APPEAL SUMMARY

| Appeal ID: 20772 | Project Address: 200 NW Royal Blvd, Lot #3 |

APPEAL INFORMATION SHEET

Code Section R302

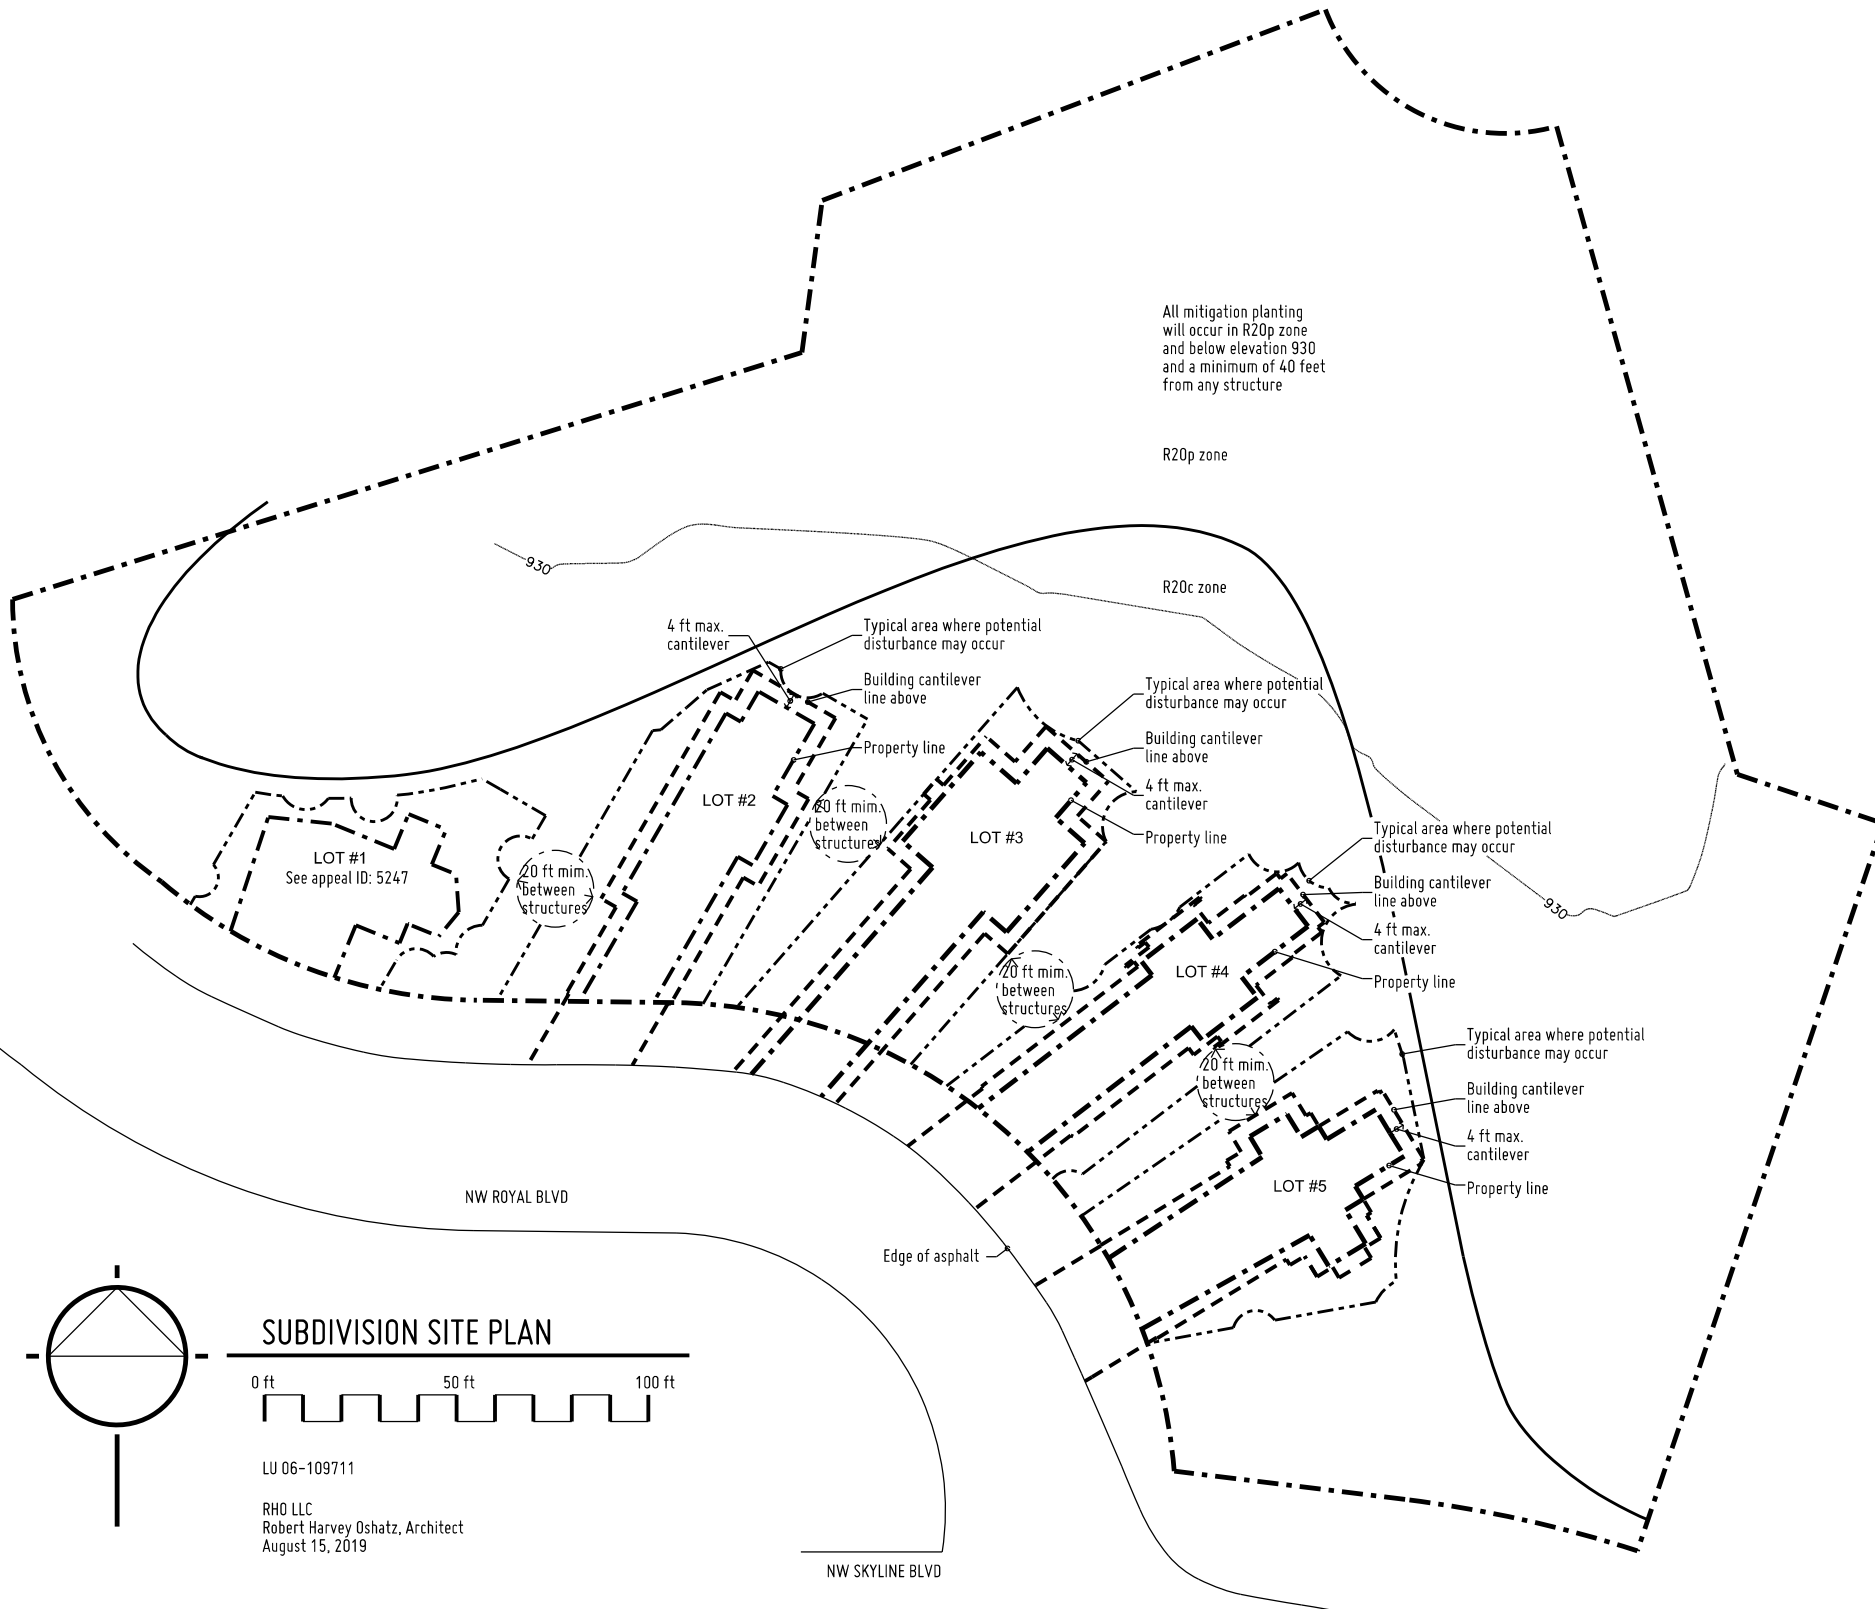
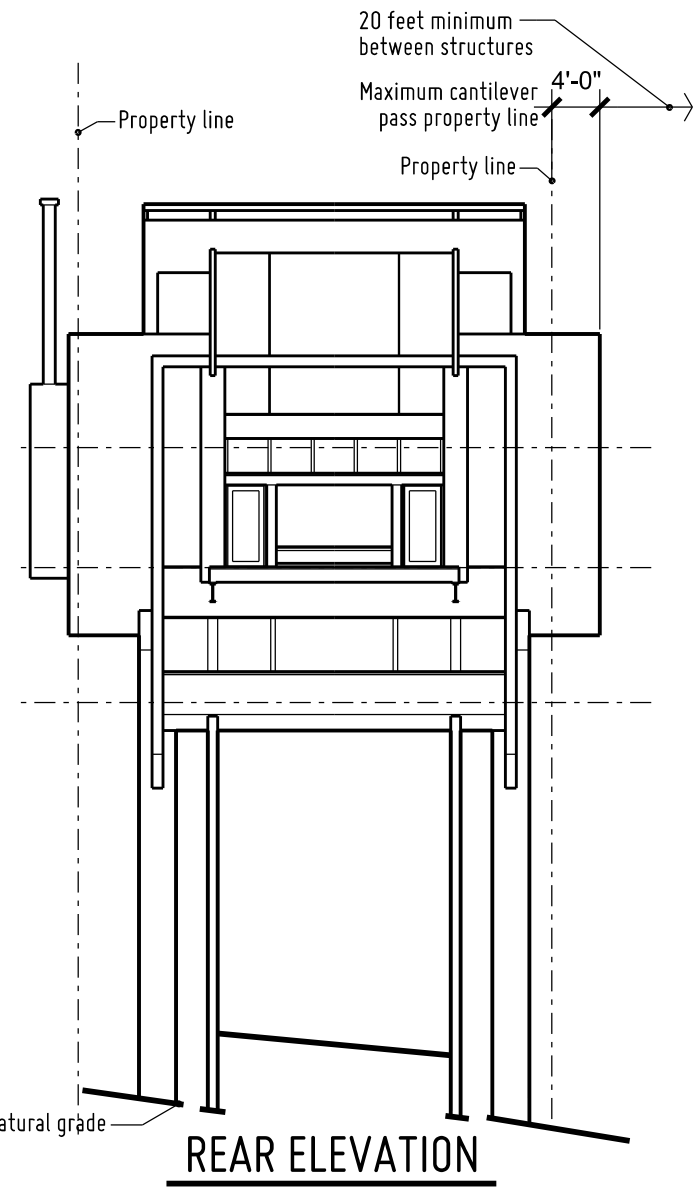
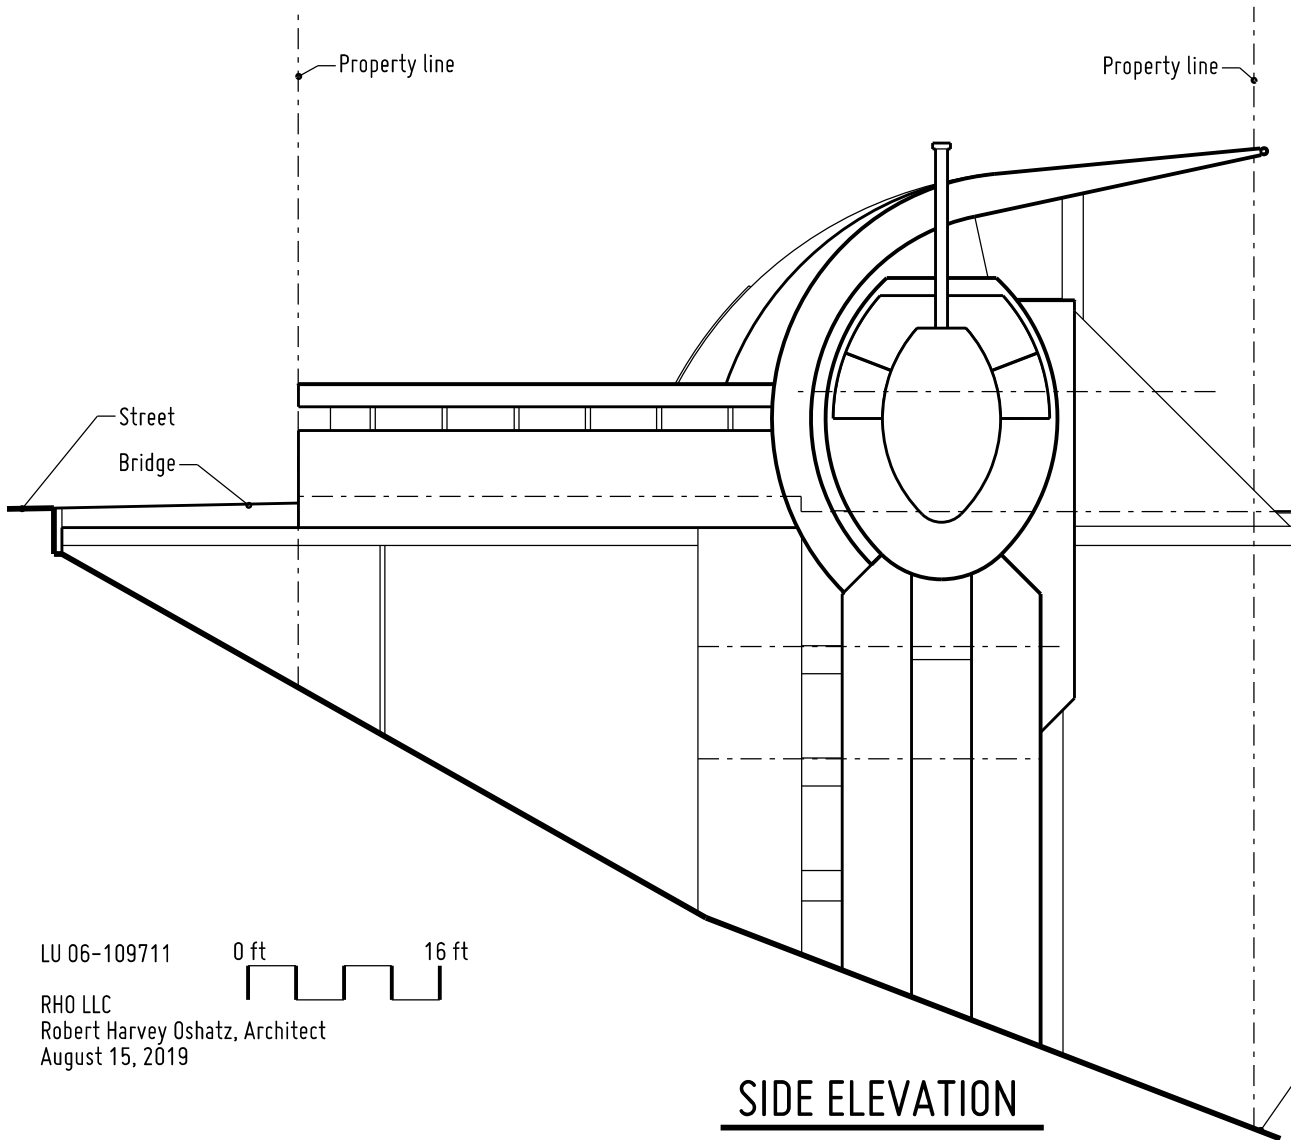
At this time, I am applying for a building code appeal on Lot #3 to cantilever as shown in the attach drawings into the subdivision private common green area. The steeply sloping downhill site requires steel H-piling supports. Horizontally at street level and supported by the piling will be a steel and wood bridge. The house will be built on top, hung from and cantilever out from the bridge. The cantilevering in a cantilever easement area beyond the individual property lines (see reason for alternate) will be of conventional wood frame construction supported by steel and engineered lumber beams. The finish exterior walls and roof will be of sheet-metal, wood and stucco siding.

Section R302.1 of the 2005 Oregon Residential Specialty Code is concerned with public safety. It requires that openings are not permitted less than 3 feet from a property line. Essentially this results in a separation of openings between structures of at least 6 feet to prevent fire spreading. In this appeal, for Lot #3 will be at least 20 feet away from any future structure on Lot #2 and Lot #4 (as required by the subdivision approval). This is greatly exceeding the 6 feet suggested by R302.1. Thus, the design follows the intent of the code and more than satisfies it.

I feel code guide OSSC/32/#1 should not apply in this case. In the past it has been targeted for cantilevering into public common areas that is used by the public. This is a case where the structure is cantilevering into its own privately not open to the public green space. When the subdivision is look at with its private common green space (which is not open to use by the public and since the site is steeply sloping and the structures are not design for their occupants to use the private common green space) in essence the house is meeting the concerns of a residence built in a R20 zone. In reality except to meet zoning requirements of an environmentally sensitive site the property lines are imaginary (in essence the planning department is saying this by going along with the concept of cantilevering over the property lines and requiring the residence to be a minimum of 2,000 sf).

Openings in exterior walls at property line: Hold for additional information.
Appellant may contact John Butler (503 823-7339) with questions.
